CULTURAL RESOURCES OFFICE PRESERVATION BOARD

REGULAR MEETING MONDAY FEBRUARY 27, 2012 1015 LOCUST ST. #1200 4:00 P.M.

FROM: Jan Cameron, Preservation Administrator, Cultural Resources Office
SUBJECT: Preliminary review to construct two three-story single-family houses

ADDRESS: 1412 Mississippi Avenue

RENDERING OF PROPOSED BUILDINGS

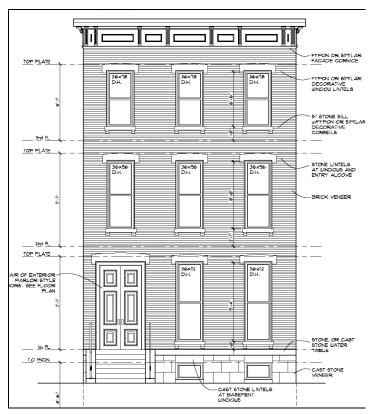
<u>Complies.</u> The buildings' massing is similar to the historic three-story town houses on this block of Mississippi and to the Model Example submitted.

NORTH ELEVATION — INTERMEDIATE FACADE

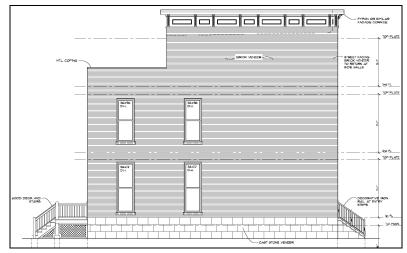
<u>Complies</u>. The buildings will be raised a similar height above grade as the buildings to the south; the front foundations will be veneered in an appropriate stone.

FRONT ELEVATION

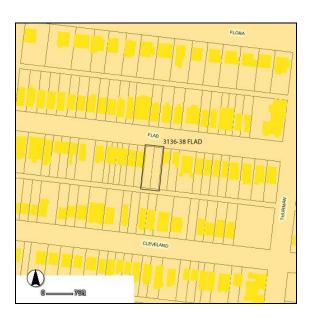
<u>Partly complies</u>. Based upon the street elevation submitted, it appears that the building will be within 15% of the average height of buildings on the block; and floor heights appear similar to the adjacent 1½-story gambrel houses.

Proportions of the openings on the front elevation are generally consistent with historic openings on the block, being narrow in relation to their heights. However, they are somewhat smaller in size than windows of adjacent properties.

EXAMPLES OF HALF-TIMBER GABLE DESIGN SUBMITTED BY APPLICANT

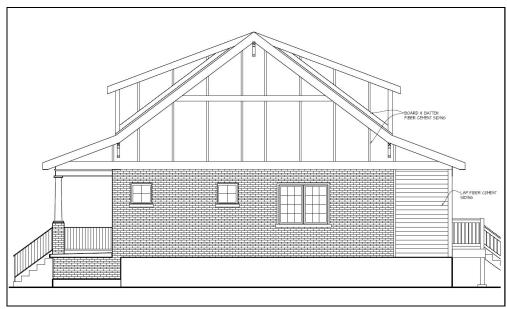
<u>Complies</u>. The front elevation and majority of both side elevations will be brick. Half-timbering will be introduced on the front dormer and side gables, a façade detail that is common in historic Craftsman houses.

FRONT ELEVATION WITH SEVERAL "MUNTIN" STYLES

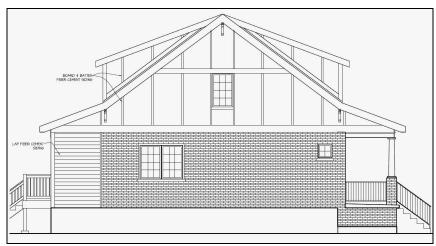
In addition, while the applicant has agreed to use exterior-applied muntins on the front elevation, due to cost considerations he asks that on the sides and rear, he be allowed to use decorative dividers installed between the glass thermal panes. Such an installation does not comply with the historic district standards, as the dividers do not replicate the depth and shadow lines of true muntins. The staff has suggested that muntins be eliminated entirely, but the owner would like to retain the decorative appearance of the windows and would prefer a consistent sash throughout the house.

The final design of the window muntins/dividers has not been selected, and will be based on availability and cost. The muntin/divider designs under consideration are depicted below.

3663 FOREST PARK AVENUE

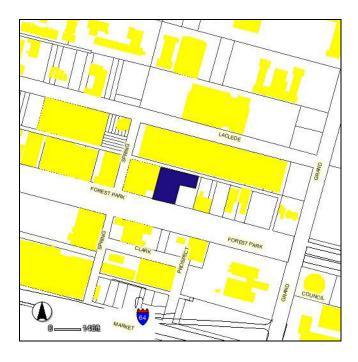
The Cultural Resources Office recommends that the Preservation Board grant approval for the demolition without requiring the submittal of a building permit application for the proposed hotel to be built on the property.
